# SERVICE BULLETIN

## INSTALLATION OF 075-17600 TORQUE PLATE SUBASSEMBLY AND 159-03500 DISCS IN PARKER 30-189 BRAKE ASSEMBLY

- EFFECTIVITY:** All 30-189 brakes that are not to the 30-189A configuration.
- REASON:** This bulletin provides a procedure for the installation of the 075-17600 Torque Plate Subassembly and 159-03500 Discs in the 30-189 Brake Assembly in place of the 065-15300 Torque Tube, 074-05400 Back Plate Assembly and 159-01300 Discs. This bulletin will allow for the field installation of the Torque Plate Subassembly (P/N 075-17600) and Discs (P/N 159-03500) on a Cessna Model 500, 501, 550 or 551 aircraft for the purpose of improving wear and performance.

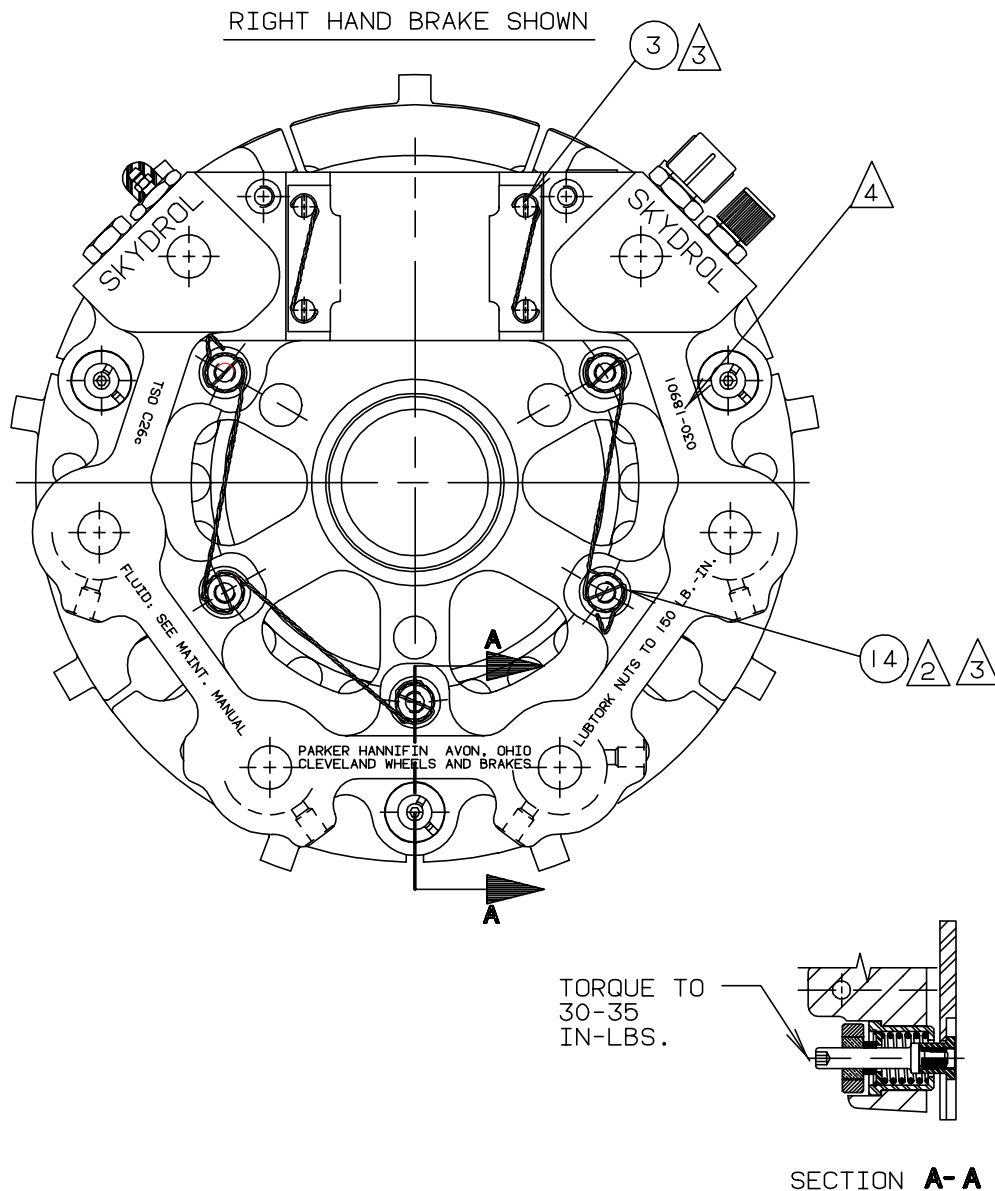
- C. Remove and discard 074-05400 Backplate Assembly, 065-15300 Torque Tube and 159-01300 Discs.
  - D. Remove and retain one (1) Center Stator Assembly (P/N 242-00700).

- A. Install Disc (P/N 159-03500), Center Stator Assembly (P/N 242-00700), and Disc (P/N 159-03500) onto 075-17600 Torque Plate Subassembly keeping the wear surfaces oriented as they were on the 065-15300 Torque Tube when removed.

- B. Install Cylinder Assembly (with pressure plate attached) onto the 075-17600 Torque Plate Subassembly, aligning holes with the tapped holes on the lugs of the Torque Plate.

- C. Next, place 095-02800 washer onto the 103-85300 bolt and apply MIL-T-5544B anti-seize compound to both surfaces of washer, under bolt head and threads of bolt. When installing washer onto bolt, the countersink on the washer must face bolt head or bolt failure may result.

- D. Install five (5) 103-85300 bolts thru cylinder into torque plate subassembly, snug down and then final torque 150 lb.-in. and safety wire with MS20995C32 per MS33540.

- E. Test brake in accordance with "Testing Procedure", page 701 of 30-189A Overhaul Manual.
- F. Re-identify brake assembly with new nameplate 166-10800 as follows:

- Model - 30-189A
  - Date Manufactured - (Enter date of manufacture off old nameplate)
  - Serial Number - (Enter serial number of brake assembly)
  - Weight - 35.8#
